GOVERNMENT OF NUNAVUT

**Re: Notification of Design Modification
Water License NWB3PON0308
Sewage Lagoon Project, Pond Inlet, Nunavut.**

RE: REHABILITATION OF THE SEWAGE LAGOON, POND INLET (REV. 1)

BURMA CROSS SECTION 4

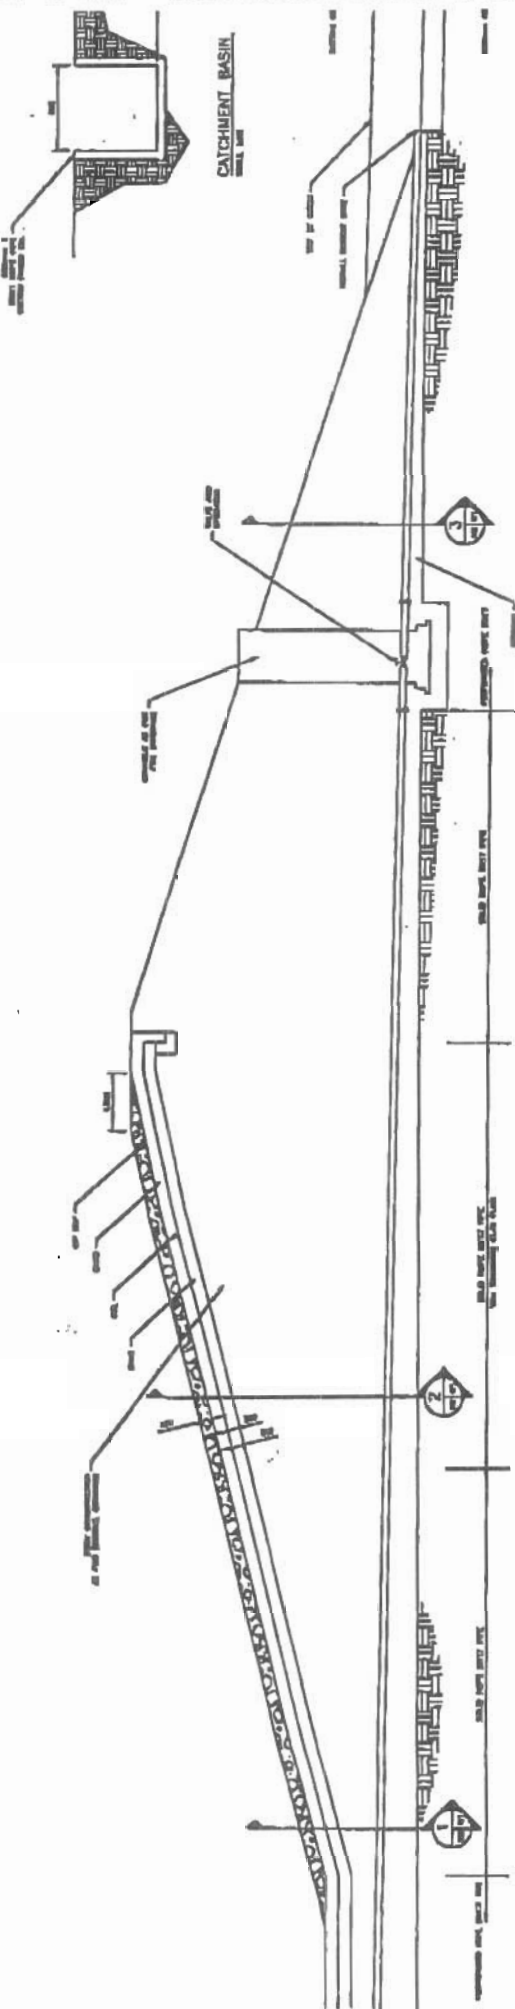
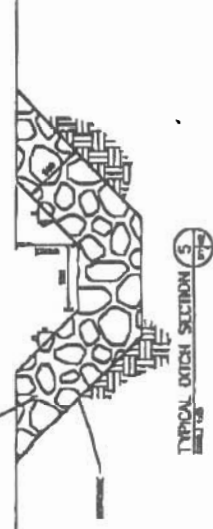
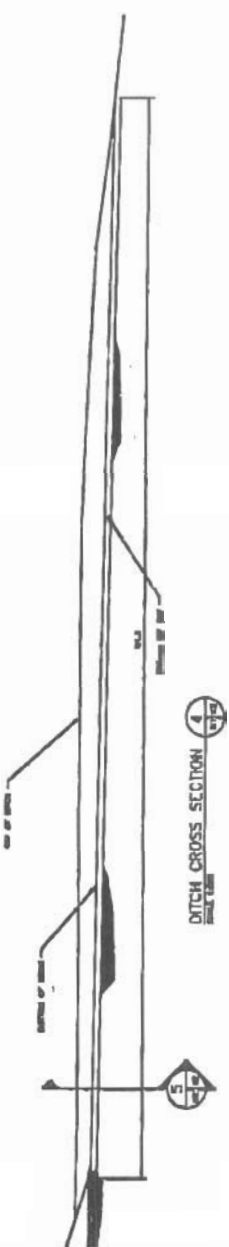
1. the installation of a sub-drain system;
2. the use of a manhole to monitor and control sub drain system;
3. the installation of riprap to protect the sand liner cover as an improvement to original design in order to stabilize berms;
4. construction of a cut off ditch and catchment basin (*Please refer to drawing*).

The sub-drain system underneath the base of lagoon shall be a French Drain system consisting of 150 mm perforated HDPE piping wrapped in a geo- textile sock. The crown of the drain will be located 500 mm below the base of the liner system which consists of 300 mm of sand, one layer of GCL and 300 mm of sand. The perforated pipe is bedded in a granular material of approximately 20 to 50 mm particles.

Where the under drain system goes under the berm wall, the piping is changed to solid wall piping. To prevent short circuiting, a bentonite clay plug shall be installed (10 meter length) with the berm wall. The outlet to the under drain system is controlled by a valve within an access manhole and the discharge of the under drain system is directed to a rip rap lined ditch.

Seepage cut off ditch with catchment basins is to be constructed on the down gradient side of the berm. This ditch is to be used to monitor for seepage and any seepage found in the ditch and collected in the catchment basin, will be pumped back into the lagoon.
